UNITED STATES  
DEPARTMENT OF THE INTERIOR  
BUREAU OF LAND MANAGEMENTFORM APPROVED  
OMB NO. 1004-0135  
Expires: July 31, 2010**SUNDRY NOTICES AND REPORTS ON WELLS**  
*Do not use this form for proposals to drill or to re-enter an abandoned well. Use form 3160-3 (APD) for such proposals.*5. Lease Serial No.  
NMNM0375257

**SUBMIT IN TRIPLICATE - Other instructions on reverse side.**8. Well Name and No.  
AVALON FEDERAL 29. API Well No.  
30-015-2149110. Field and Pool, or Exploratory  
BURTON FLAT MORROW11. County or Parish, and State.  
EDDY COUNTY, NM

OXY USA Inc. - Proposed  
Avalon Federal #2  
API No. 30-015-21491

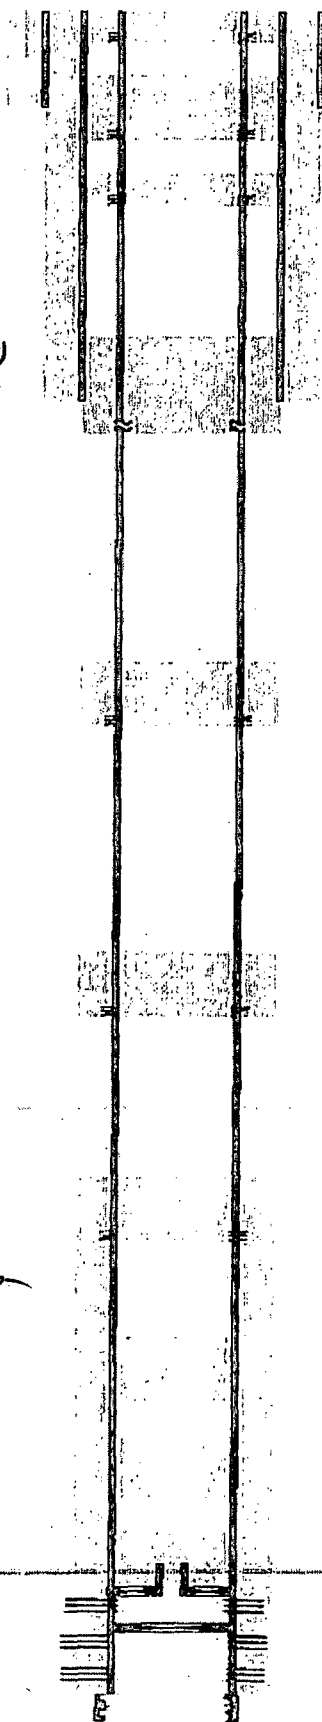
\* Add T/Canyon from 9600'-9400'.

9600 - 9400 Top Canyon
